ADMINISTRATIVE AMENDMENT

MASTER SITE PLAN

2020008 - MASTER SITE-PLAN

**RE: ADMINISTRATIVE AMENDMENT REQUEST
PR: 2021-004978
ABQ CARPENTERS TRAINING CENTER**

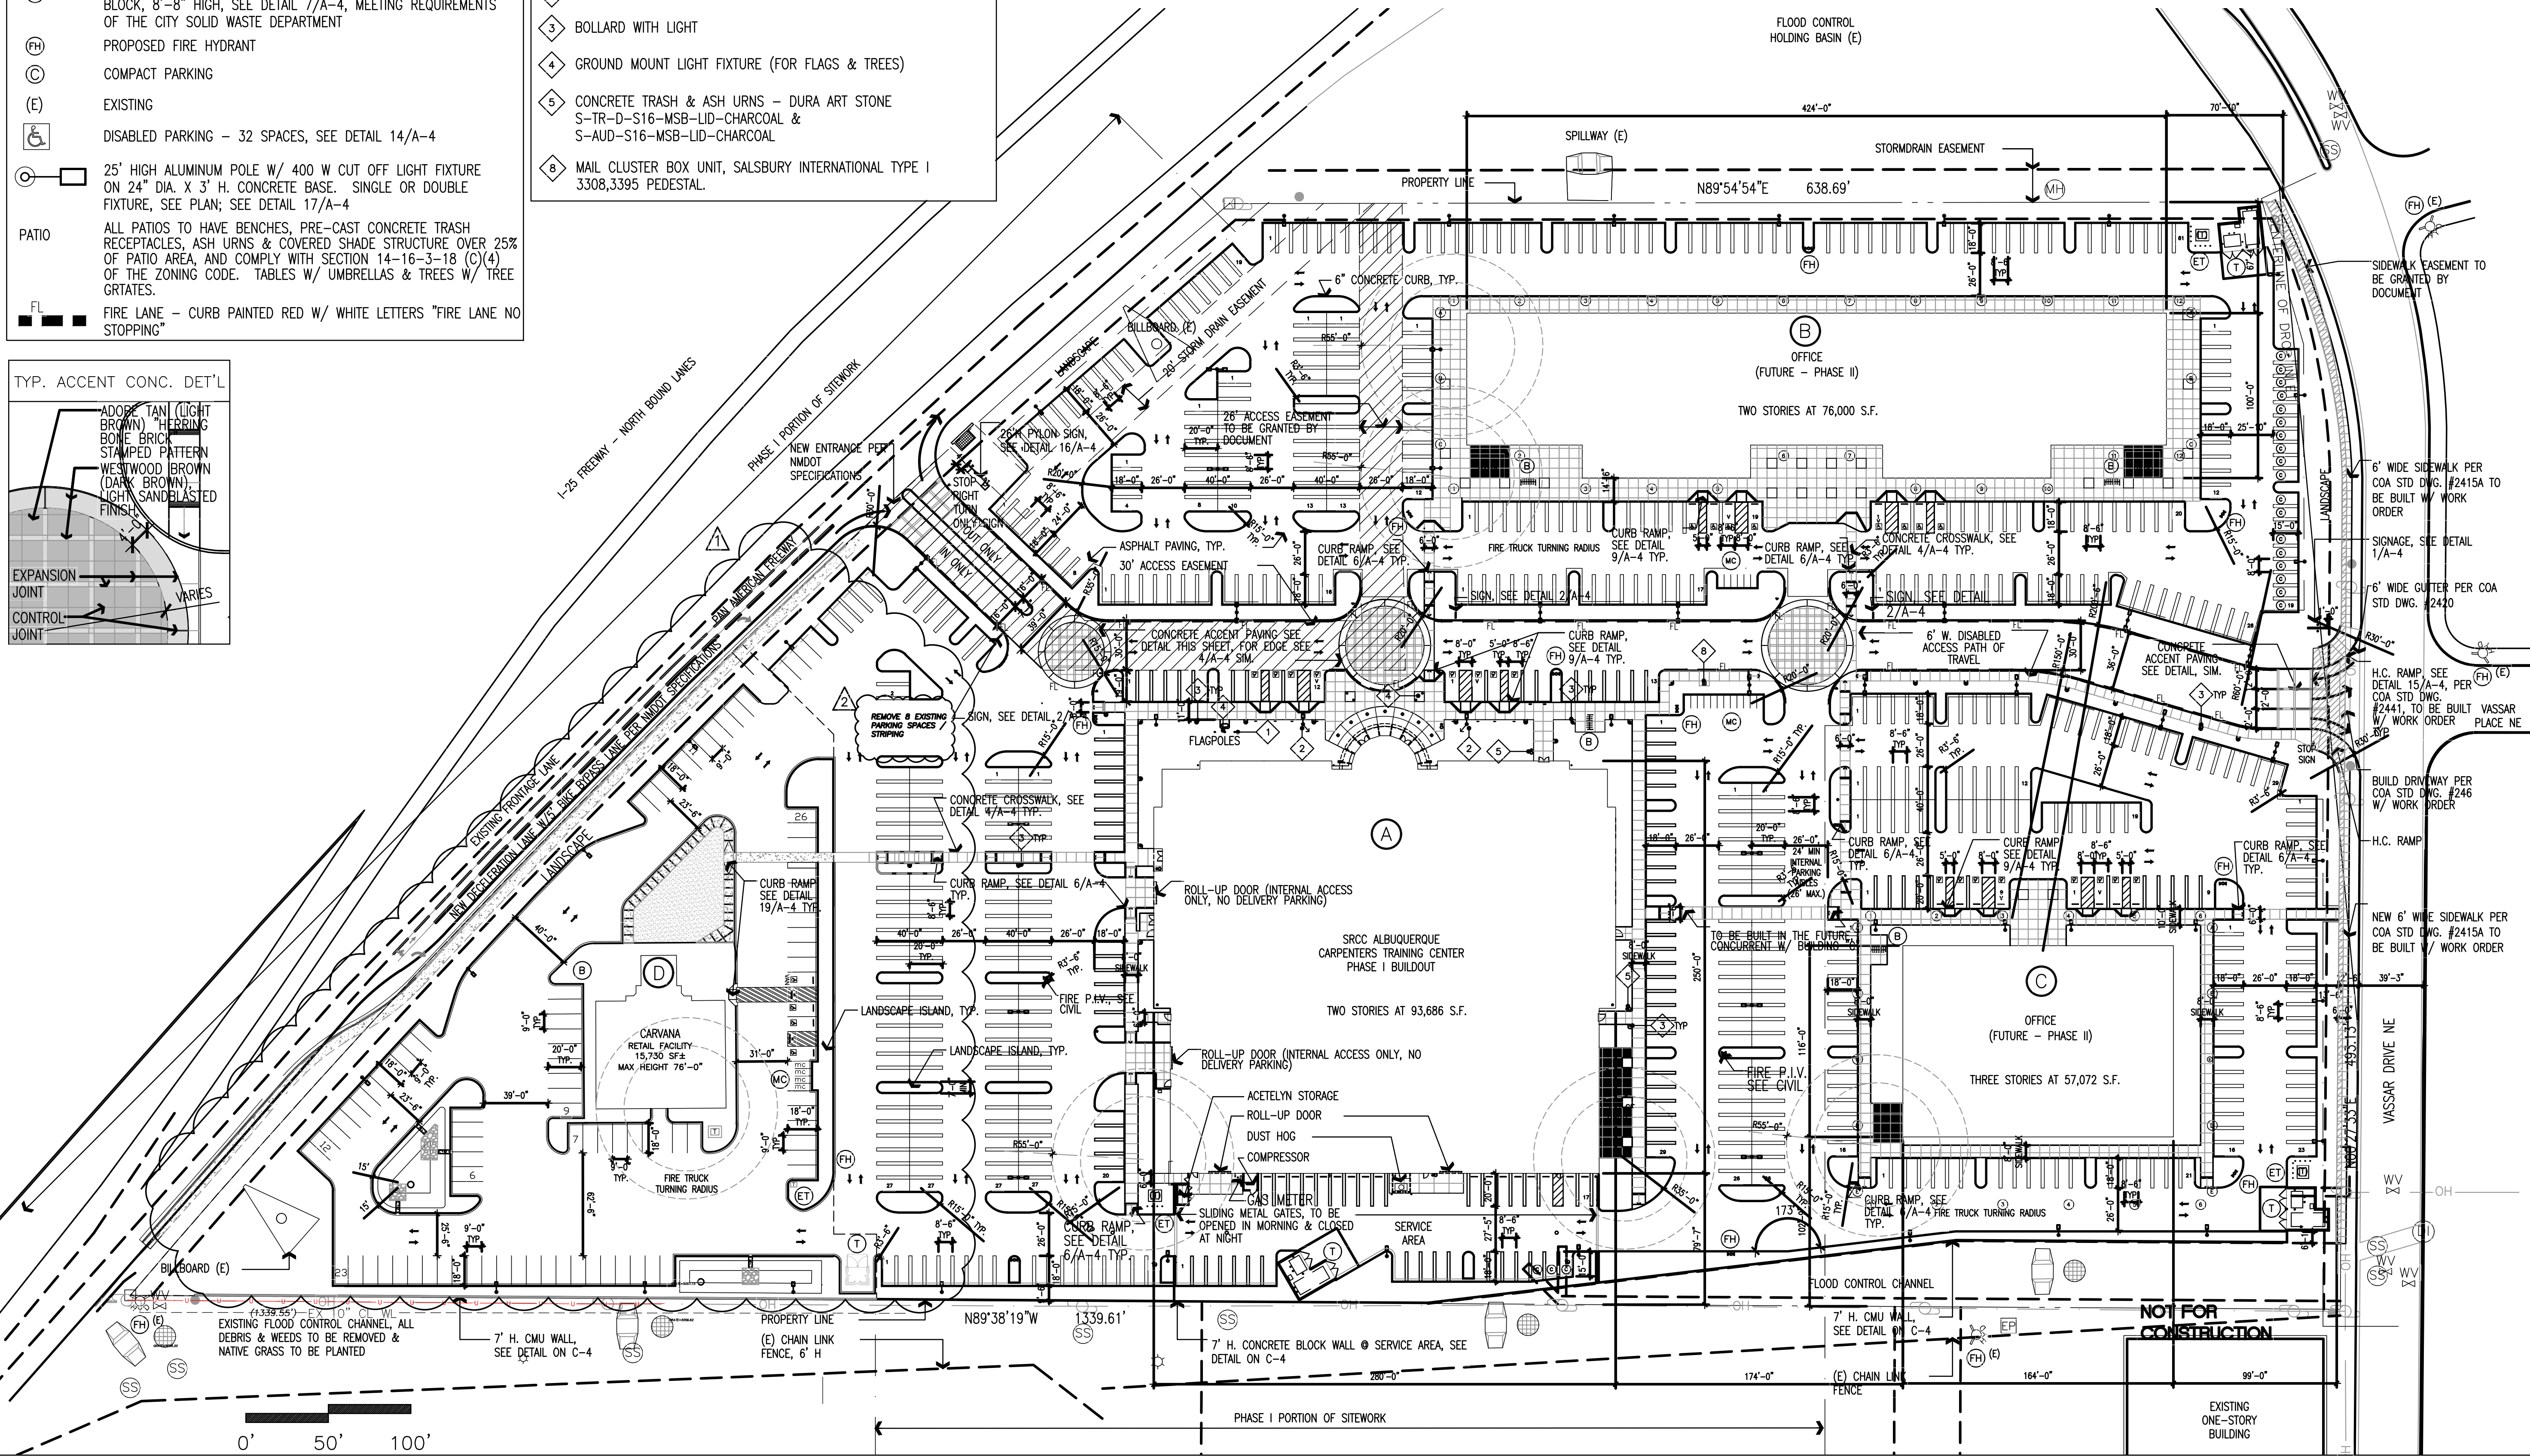
1. Please provide a comparison for parking calculations to justify the no impact to IDO requirements with the elimination of 8 parking stalls. So, please coordinate with Zoning on this issue.

2. See the Traffic Impact Study (TIS) thresholds. In general, a minimum combination of 100 vehicles entering and exiting in the peak hour warrants a Traffic Impact Study. Visit with Traffic Engineer for determination, and fill out a TIS Form that states whether one is warranted. In some cases, a trip generation may be requested for determination or a comparison of existing condition versus proposed. If a TIS exists, please provide and/or coordinate with Matt Grush to address these concerns (IF APPLICABLE-let know).

3. Coordinate with NMDOT, if you are changing any infrastructure that might impact the overall traffic flow for the ingress and egress of the frontage site access (IF APPLICABLE).

6. The minimum required ADA pathway is 6 feet from the handicapped parking to the building. Please provide pathway for all proposed handicapped parking stalls. This can be accomplished by striping the whole segment of the drive aisle that encompasses the handicap stalls.
The Carpenters Training Center is existing. We are not proposing any changes to the ADA parking spaces, the pathways nor the drive aisle where the ADA spaces are located.

9. Call out transitioning between the areas showing the sidewalk flush with the paving versus sidewalk adjacent to the curb. Provide necessary ramp details.
All of the pedestrian sidewalks are existing. This request does not affect any of the pedestrian connections.

The Carpenters building currently has 53,030 square feet of office and 40,565 square feet of auditorium/assembly area. Per the IDO the office is 3 spaces per 1,000 GFA which equals 160 spaces and the assembly area is 1 space per 1,000 GFA which equals 40 spaces for a total of 200 spaces. That is the number provided on the existing site after the 8 spaces are removed. There is also a blanket parking easement as shown on the enclosed plat. The revision meets the IDO requirement for parking as well as for ADA spaces and motorcycle spaces.

This is an existing site with no changes being made to the existing building. This request is only to provide an additional drive aisle to the Lot 4 which contains the Carvana site that is already approved by the City.

There are no changes to any infrastructure within or adjacent to the NMDOT right-of-way. The request is only to provide an additional drive aisle through the Carpenter Training Center Parking Lot to the Carvana parcel on Lot 4.
